ADDENDUM #002

DATE: MAY 7, 2024

ELKHORN PUBLIC SCHOOLS
ELKHORN HIGH SCHOOL
AUDITORIUM RENOVATIONS
1401 VETERANS DRIVE; ELKHORN, NEBRASKA 68022

JJA PROJECT: 3626
DRAWINGS & SPECIFICATIONS
DATED: 04/15/2024

3 ELEVATION - ACOUSTIC PANELS - HR APRON
E3.5 1/2" = 1'-0" 1' 2' 4' 6' 8' 10'

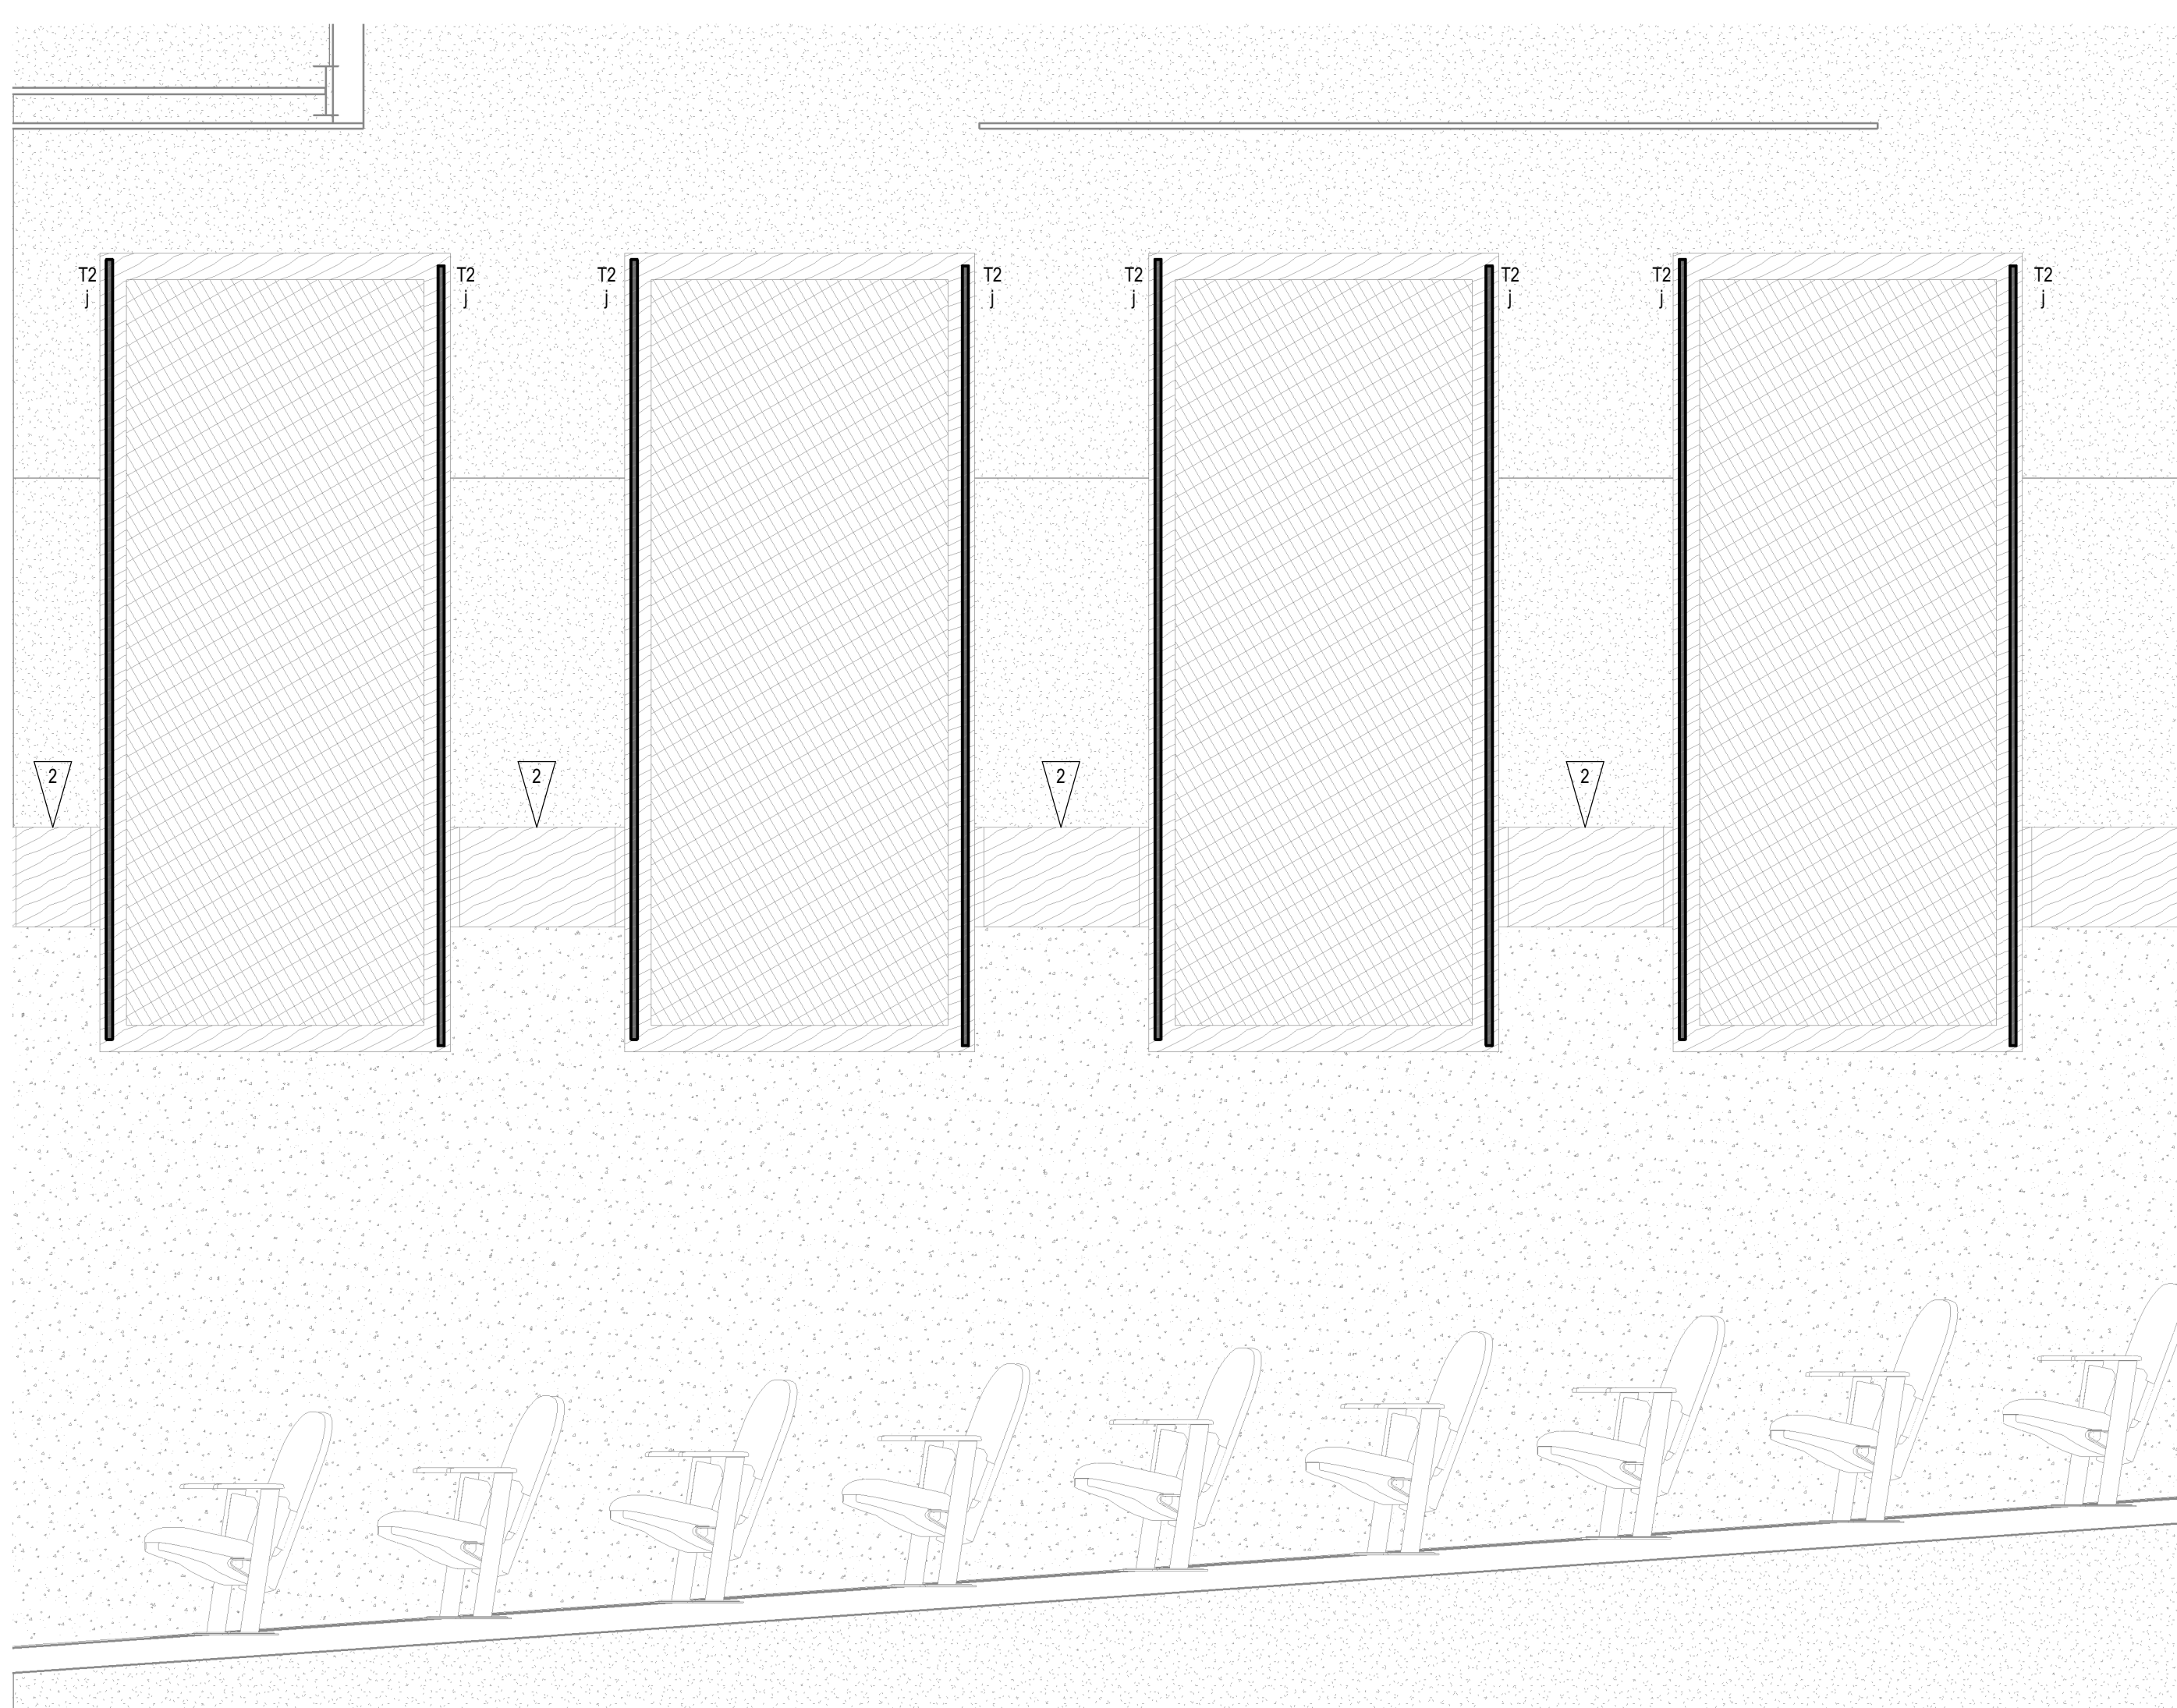
- A. Modify graphic scales for clarification.
